COMMITTEE OF THE WHOLE JANUARY 6, 2003

**SITE DEVELOPMENT FILE DA.02.046
NORWOOD PLAZA INC.
REPORT #P.1998.130**

BUILDING 'A' WEST ELEVATION

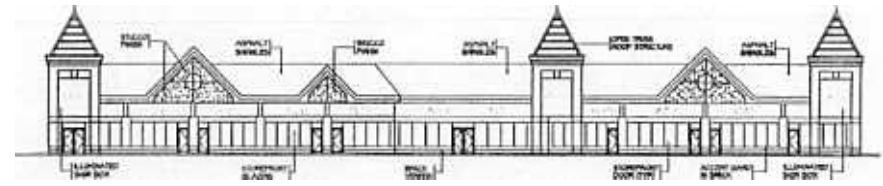
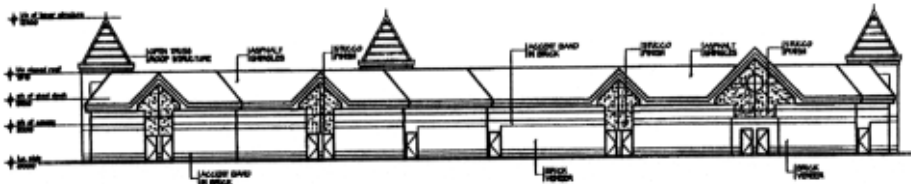
Staff is satisfied that the applicant has addressed the Guidelines. The Urban Design Department has recommended that the applicant provide additional landscaping within the parking lot area and along the front of Buildings "A" and "B".

The proposed elevations are typical of many one-storey commercial developments. The primary exterior finishing materials are brick, stucco, asphalt shingles and glass. The main front façade of Buildings "A" and "B" consist of glass, a brick veneer, and the entrance door to each unit. A shingled gable roof with accent gable ends finished in stucco, provides architectural detail to the roofline. The roof is extended to provide a covered canopy area over the pedestrian sidewalk along the front of Buildings "A" and "B". Open truss turrets are provided at each end of the main buildings to enhance the proposed elevations.

BUILDING 'B' EAST ELEVATION

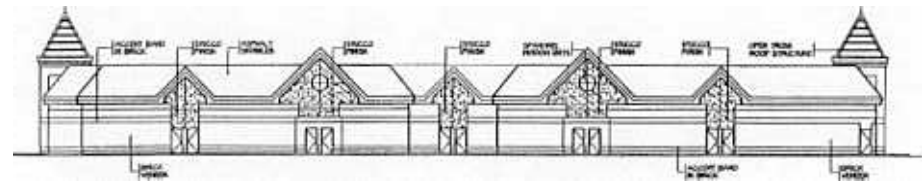
- i) the final site plan, elevations, and landscape plan be to the satisfaction of the Community Planning and Urban Design Departments;
- ii) the rear elevations for Buildings "A" and "B" facing the residential to the east be subject to final revisions by the Urban Design and Community Planning Departments; and, the elevations for Buildings "C" and "D" be subject to a future report to the Committee of the Whole;

The elevations facing Bachman Drive are comprised primarily of brick, with emergency access doors and a continuation of the roof design described above. The Urban Design Department has requested that the elevations on Bachman Avenue be improved by including a band of windows below the soffit of the roof and glass sidelights on both sides of each door. Enhanced buffer planting is also expected along Bachman Drive.
